**DANE COUNTY DEPT. OF
PUBLIC WORKS, HIGHWAY &
TRANSPORTATION**

RFB NO. 317042 - ADDENDUM NO. 1

ROOF REPLACEMENT

DANE COUNTY HUMAN SERVICES DEPT.
1202 NORTHPORT DRIVE
MADISON, WISCONSIN 53713
2018 ROOF REHABILITATION

ROOF PLAN
SCALE: 1/8"=1'-0"

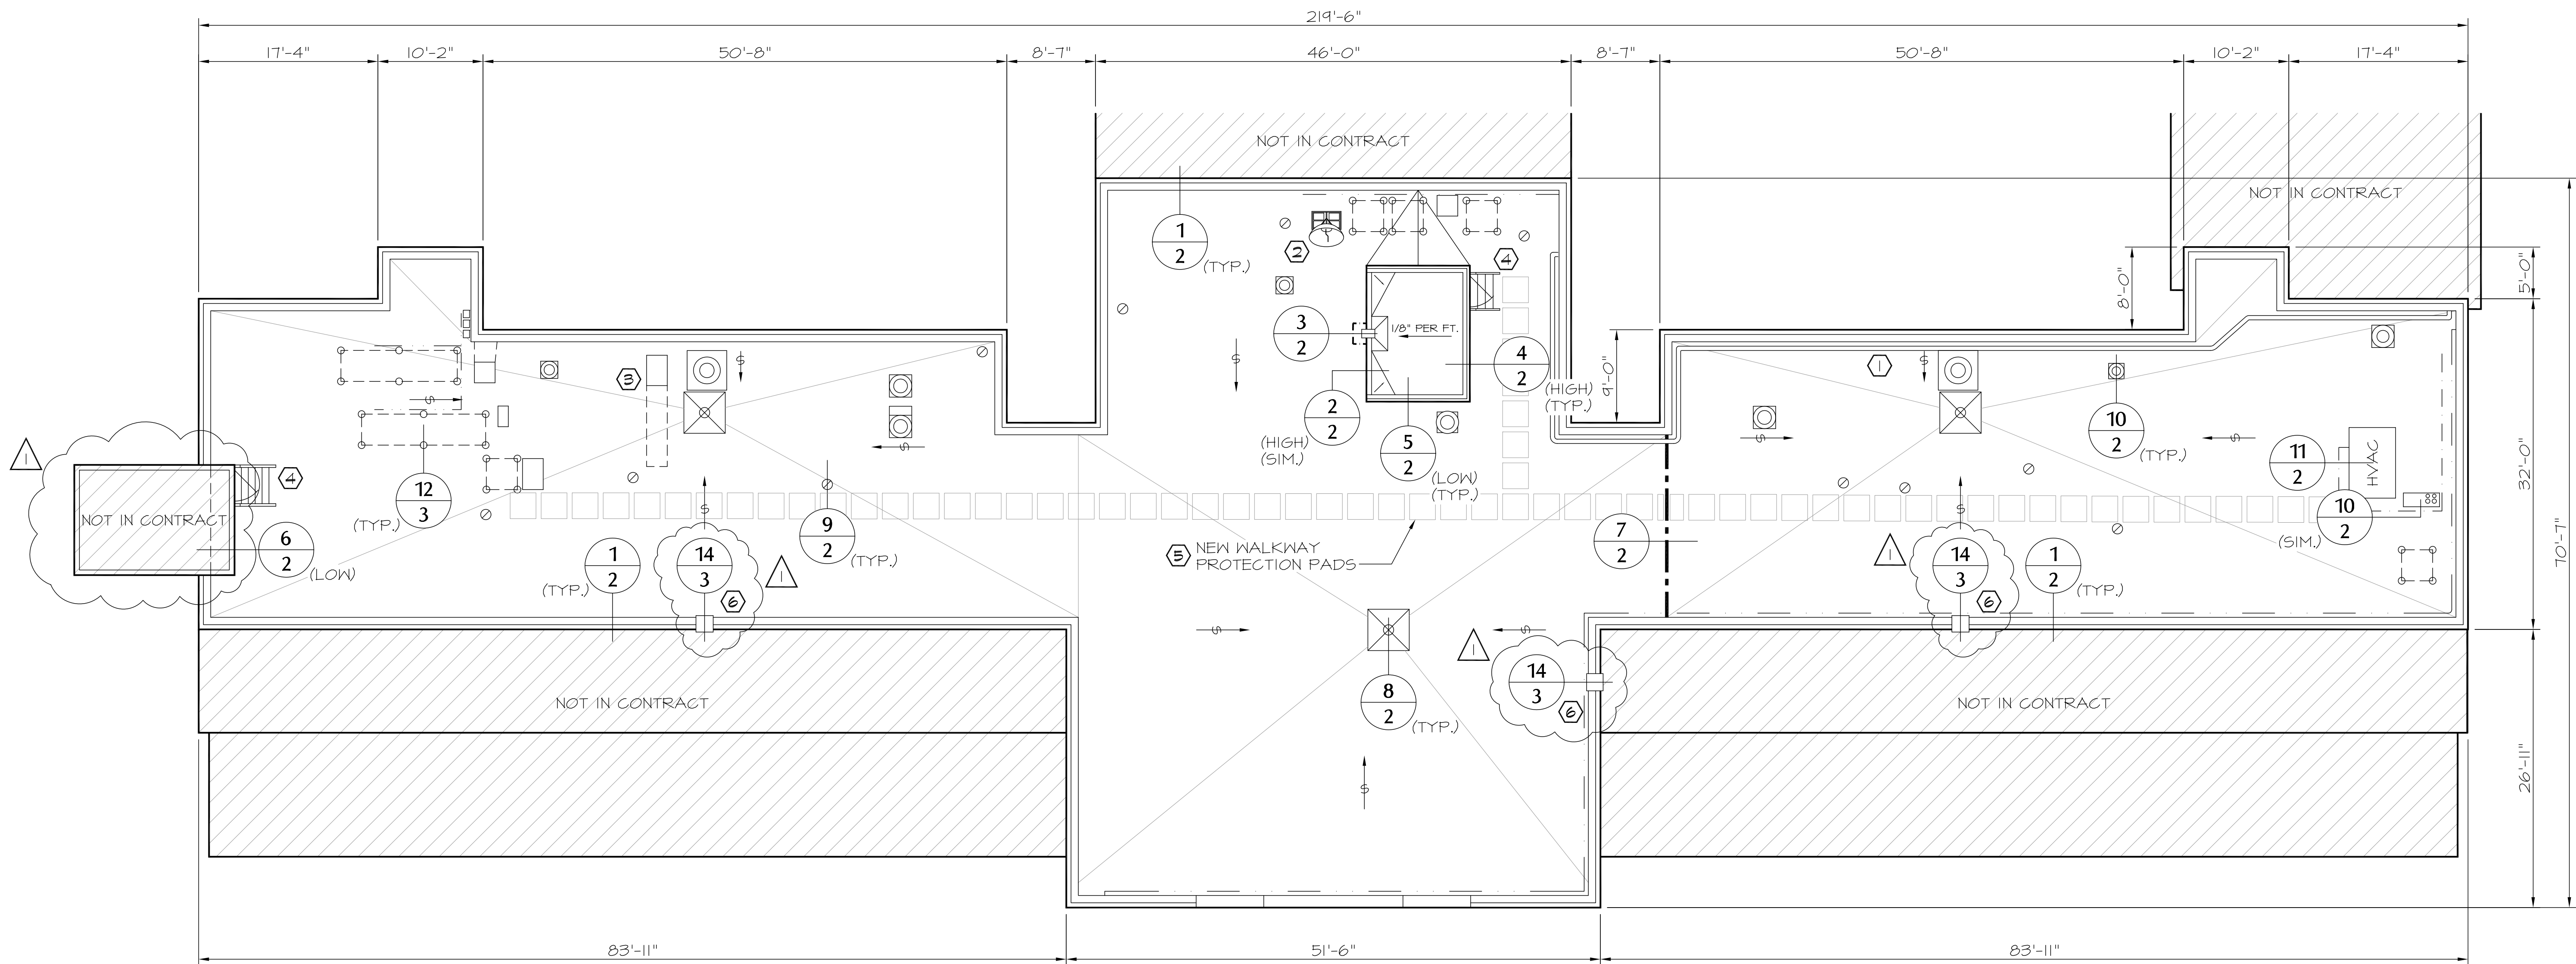
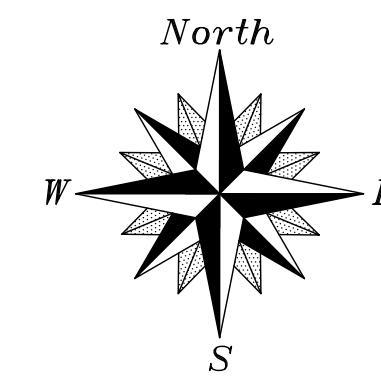
The penthouse roof on the west end of the building for the freight elevator will no longer be included in the contract for this project (area marked and designated on drawing sheet 1, issued with this addendum).
